LATE ITEM MEMO BUSINESS PAPER

GENERAL MEETING

ITEM 6 PL16/17 - Development Application - Dwelling House - 10 Yallambee Road, Berowra**Additional information with *CHANGE* to Recommendation**

ITEM 8 **PL22/17** - Development Application - Subdivision of One Allotment into Three and Construction of Three Dwelling Houses - 14 - 16 Elabana Crescent, Castle Hill

- 1.[View](#) Tree Location and Protection Plan prepared by Hornsby Shire Council dated 26 February 2017
- 2.[View](#) Stormwater Management Plan prepared by EZE Hydraulic Engineers dated 7 February 2017

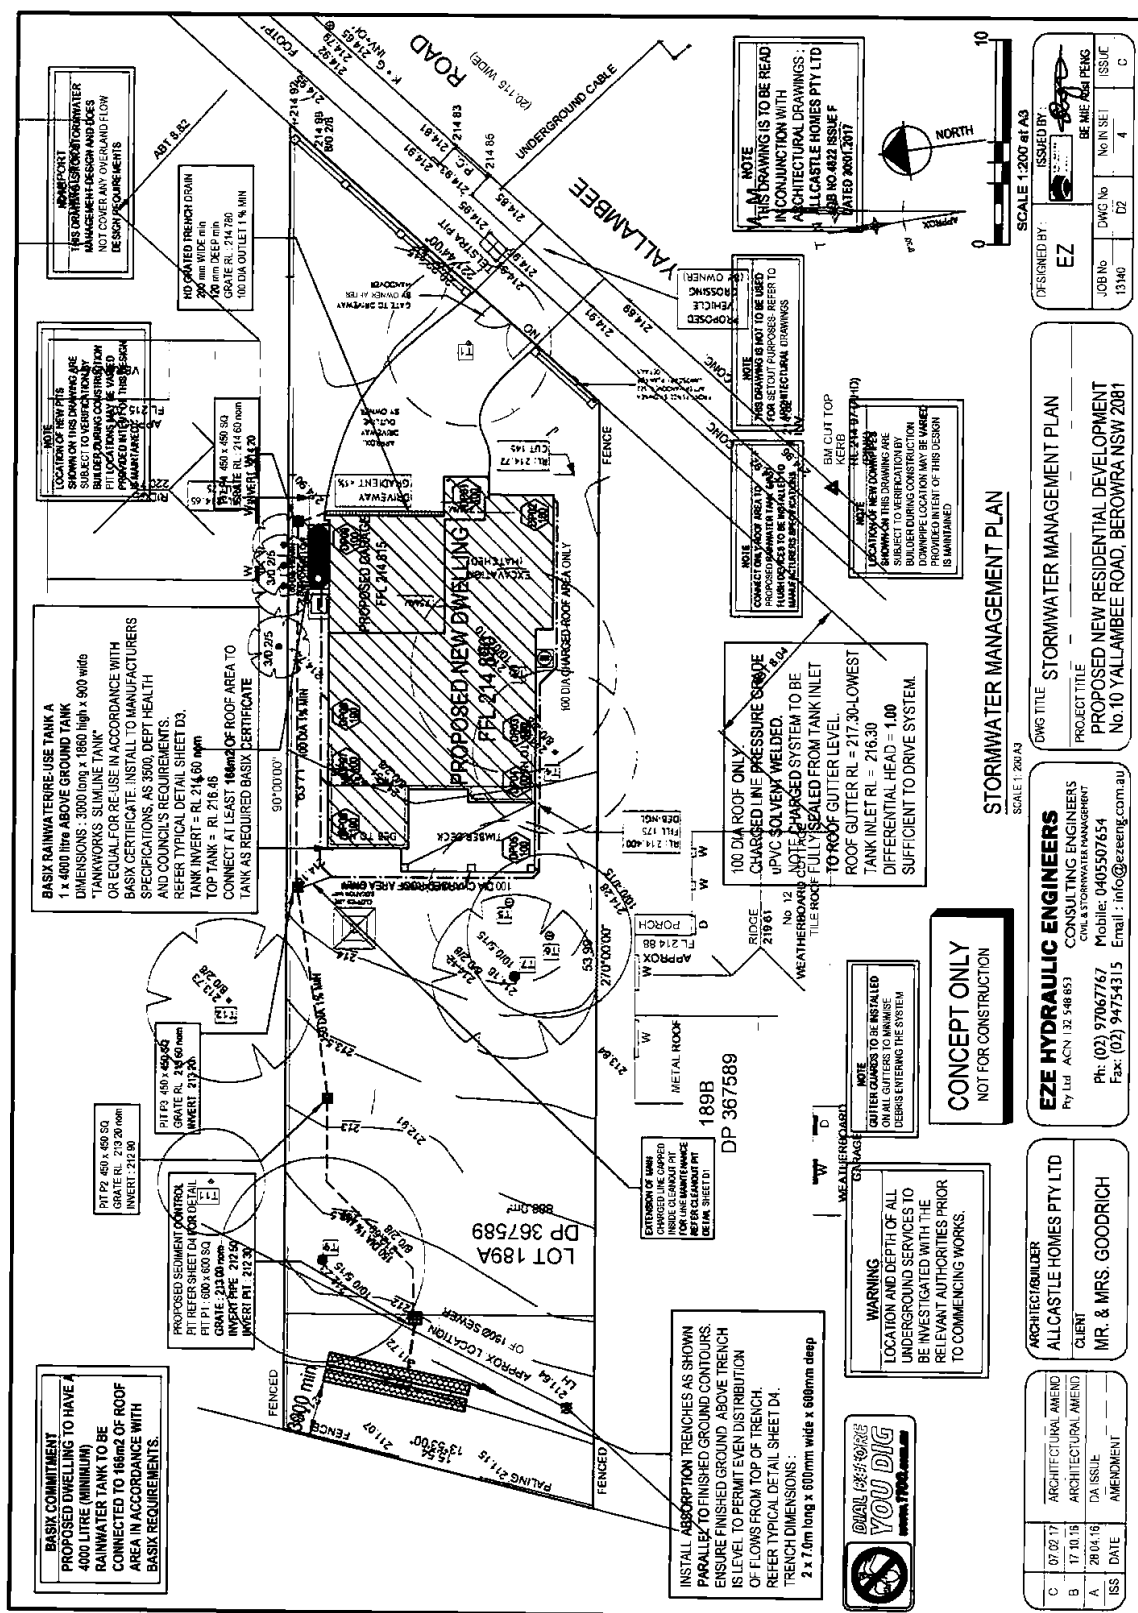
The submission notes that tree protection plan prepared by Hornsby Council dated 26/02/2017 includes 6 trees on the adjoining property drawn at half the size when compared to the tree protection plan prepared by Council dated 21/12/2016. The submitter notes that carrying out the development in accordance with misinformation provided by Council would have a significant impact on trees.

The submission comments that the attachments to Group Manager's Report No. PL16/17 did not include the Tree location and Protection Zone Plan prepared by Council. This document has been prepared by Council and is not a plan submitted by the applicant to be exhibited for public comment. Notwithstanding, to address this concern, a copy of the plan was forwarded to the submitter directly and a copy of the plan is attached for the information of Councillors.

The TPZs on the tree protection plan is prepared for indicative purposes only. The tree assessment sheet 1 prepared by Council lists each tree and specifies the extent of the TPZ. The tree protection plan includes the location of tree protection fencing to ensure the protection of trees on the adjoining properties.
